ADDENDUM NO. 3 (RE-BID)

FOR: ASU Grain Bin

May 15, 2024

Southern Tenant Farmers Museum Grain Bin Restoration Tyronza AR

AS-I.I

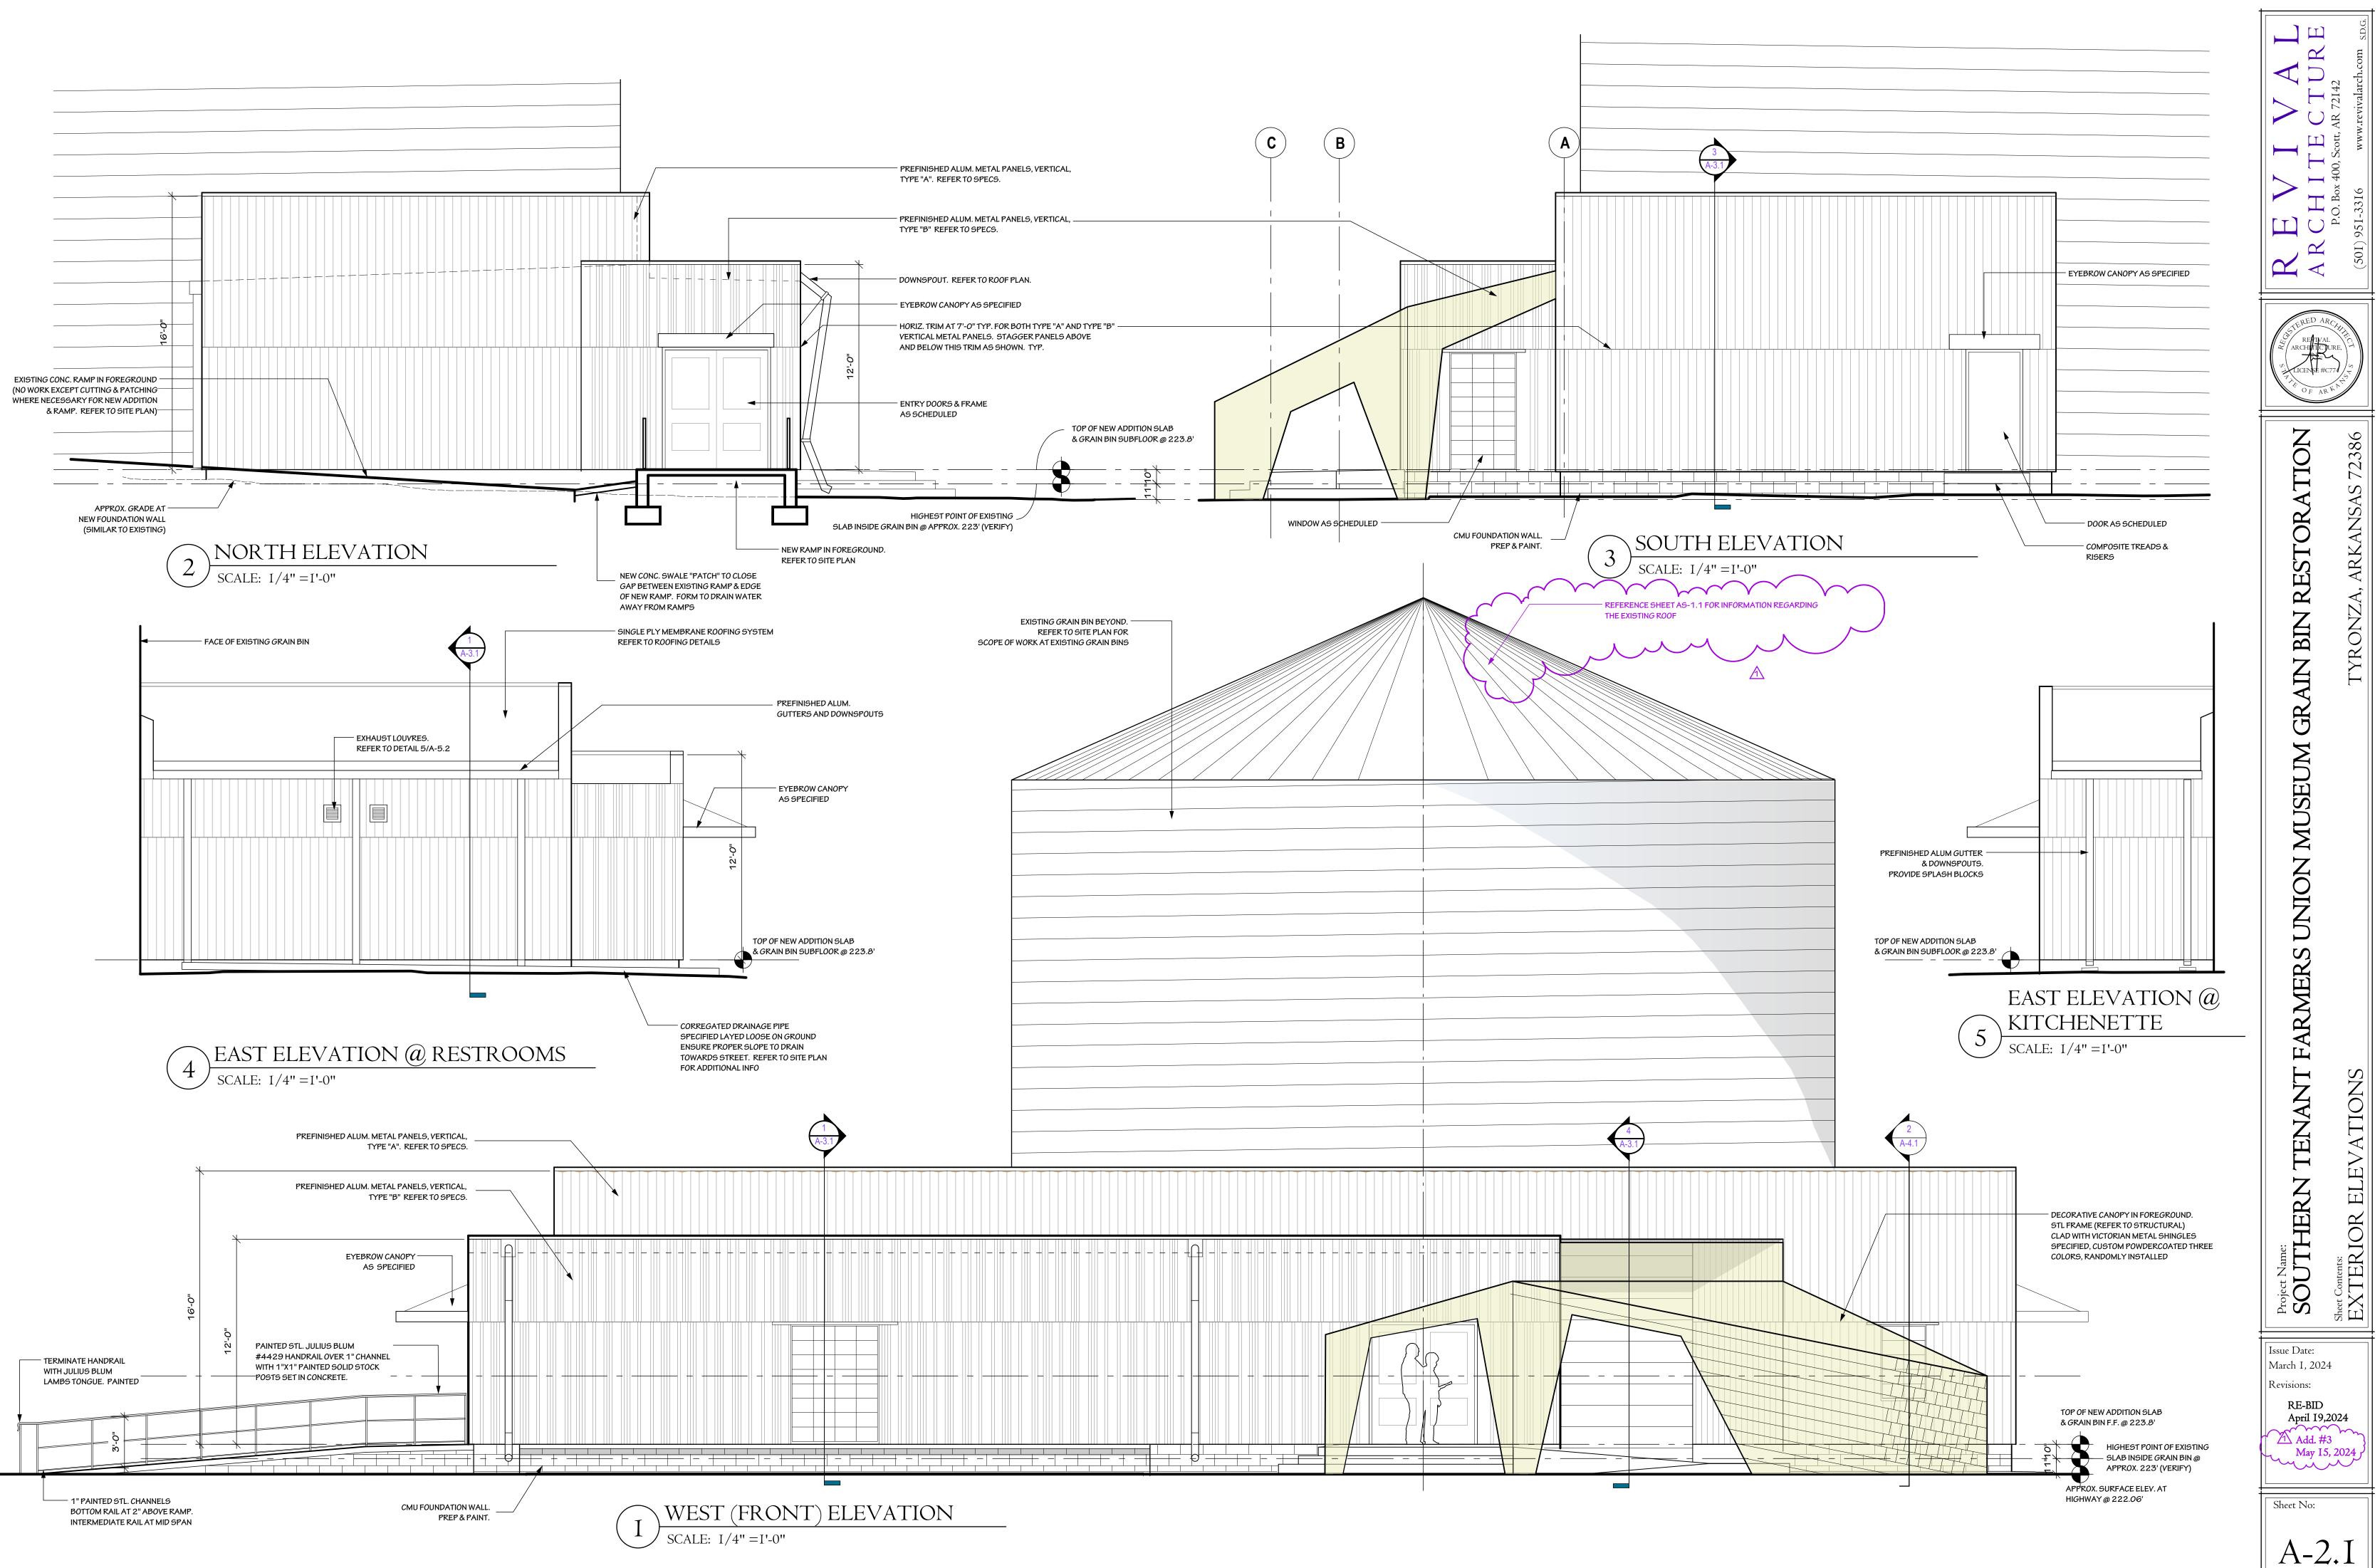
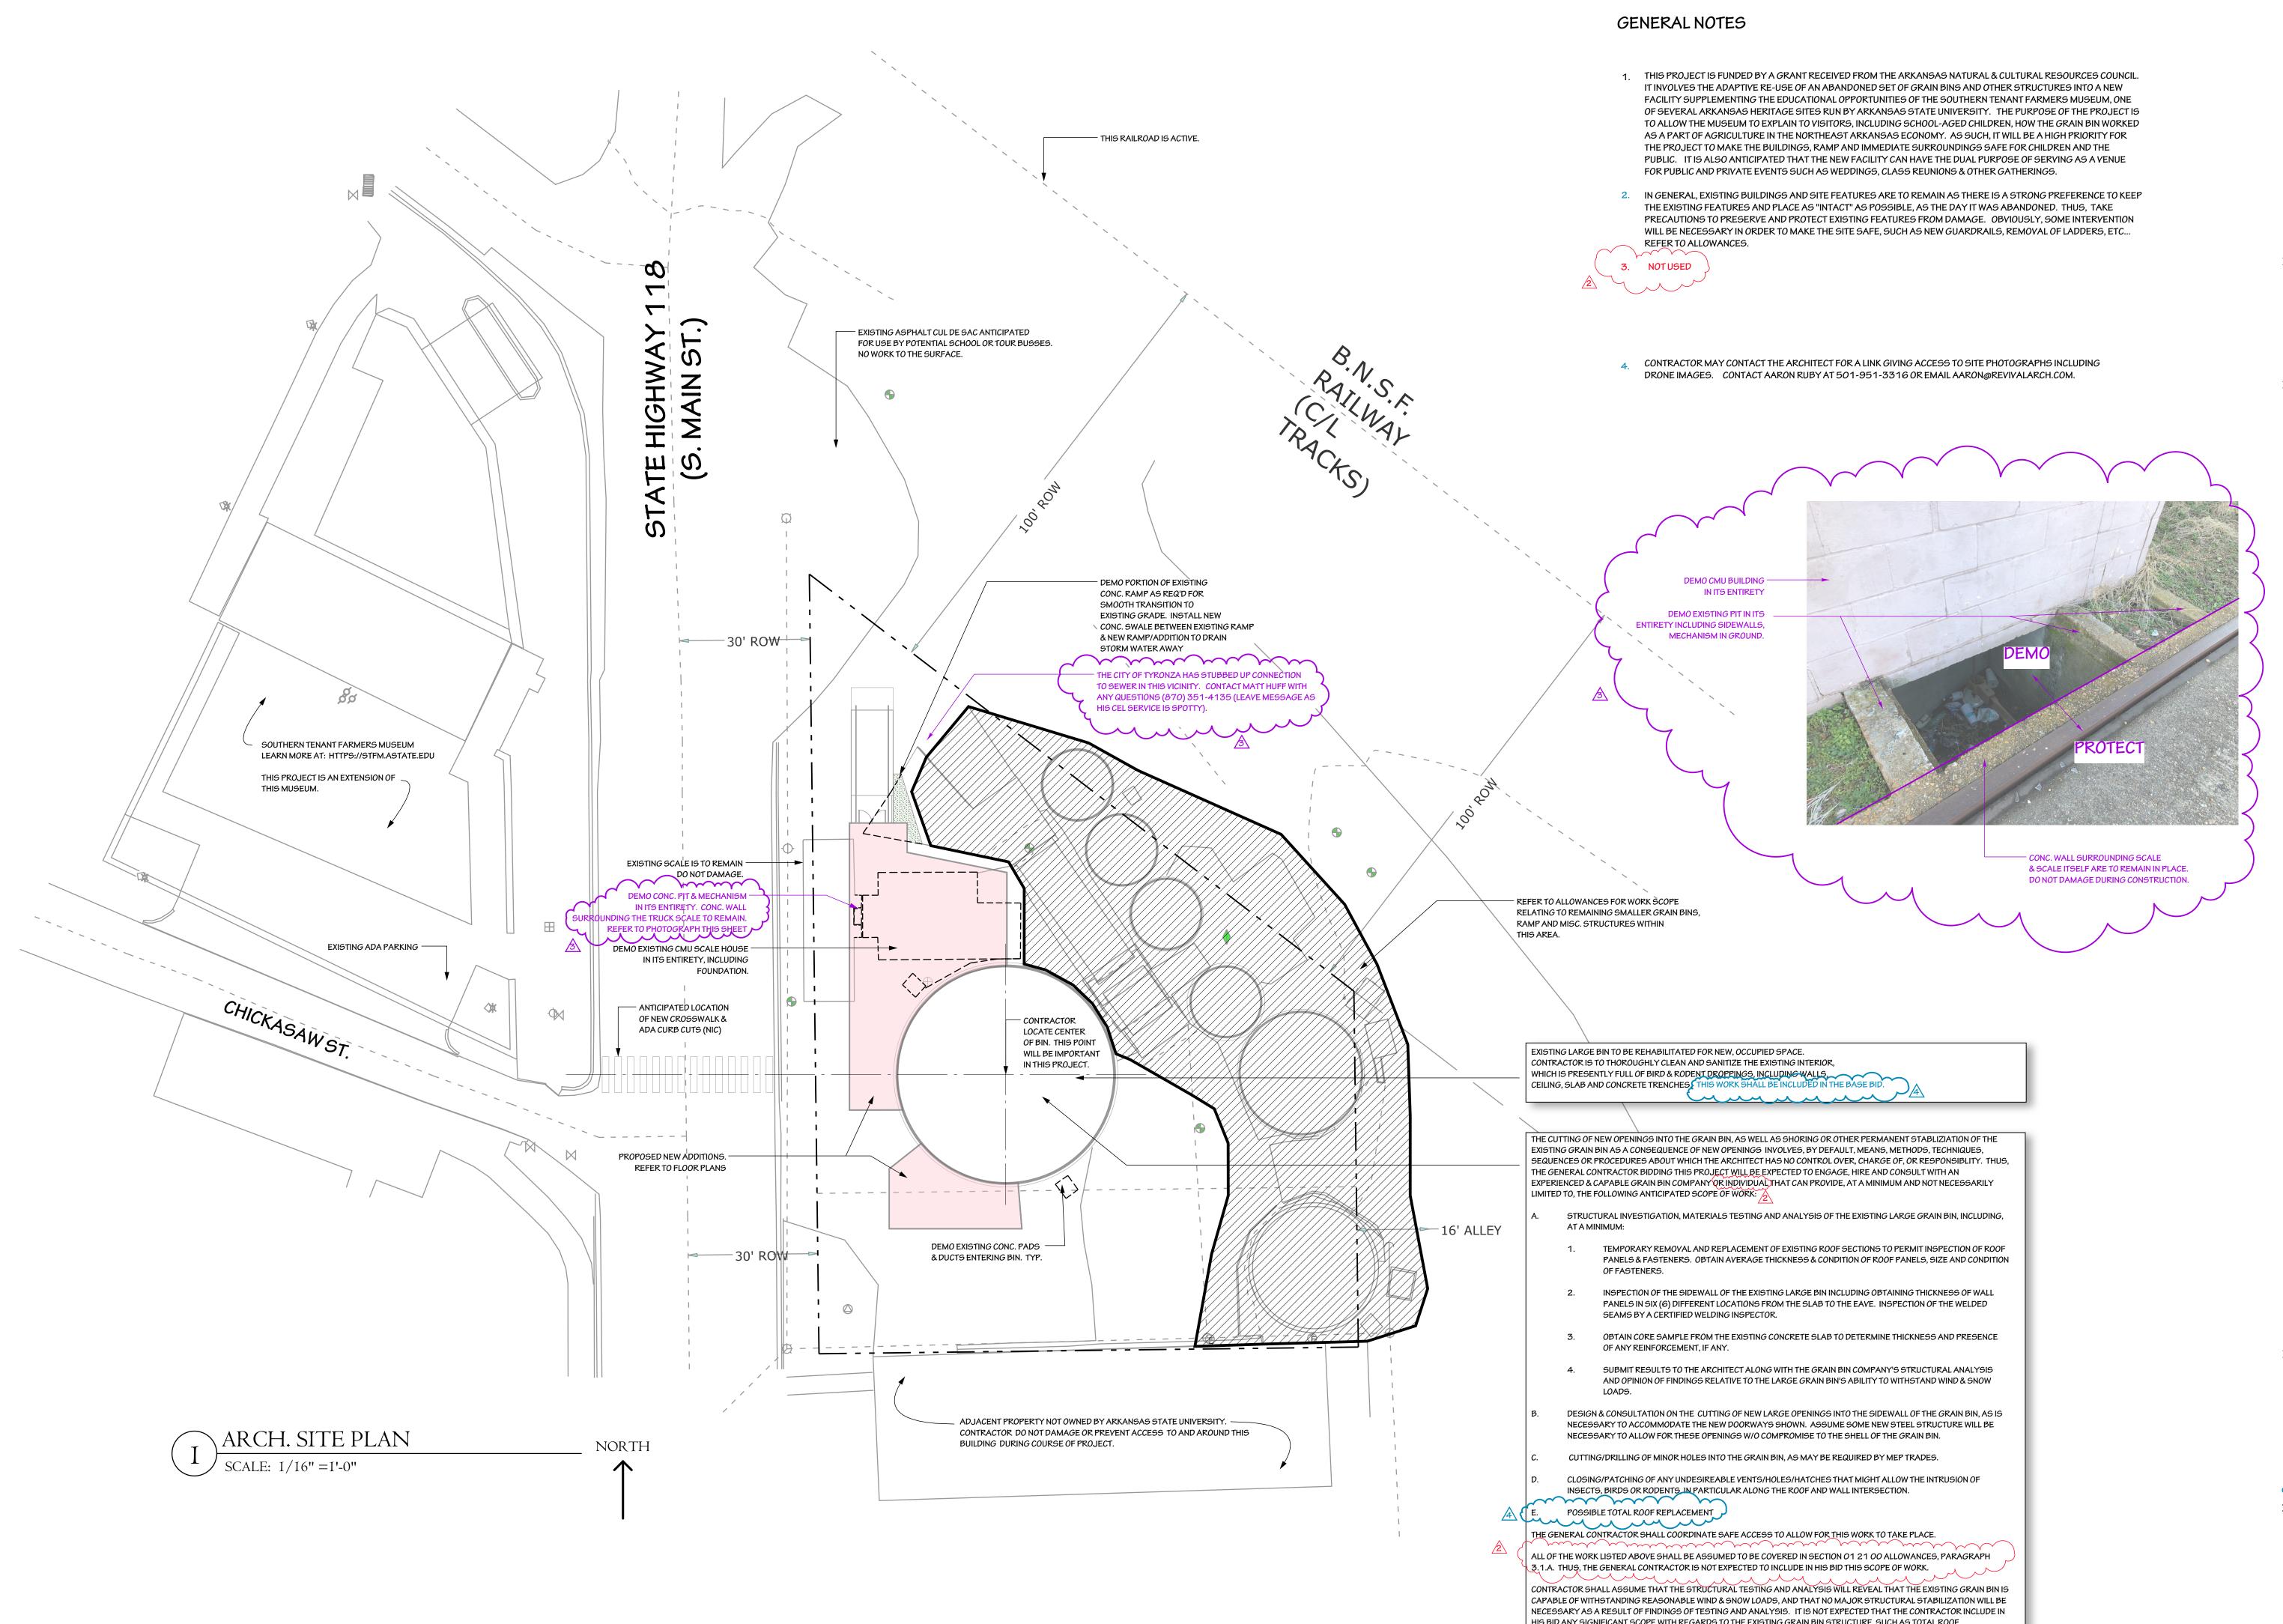
- 5. The exterior of the existing grain bin remains as-is. It is not expected to be painted.
- 6. Reference sheets P-1.1 & P-1.2. Contractor take note of where the City has stubbed up sewer roughly where indicated on revised sheet AS-1.1 (note added by Addendum #2). Additionally, water service will tap in 16' alleyway to east of existing grain bins (a water meter is presently visible in this location). Thus, it is expected that sewer and water service essentially flip from what is presently shown on P-1.1 & P-1.2.
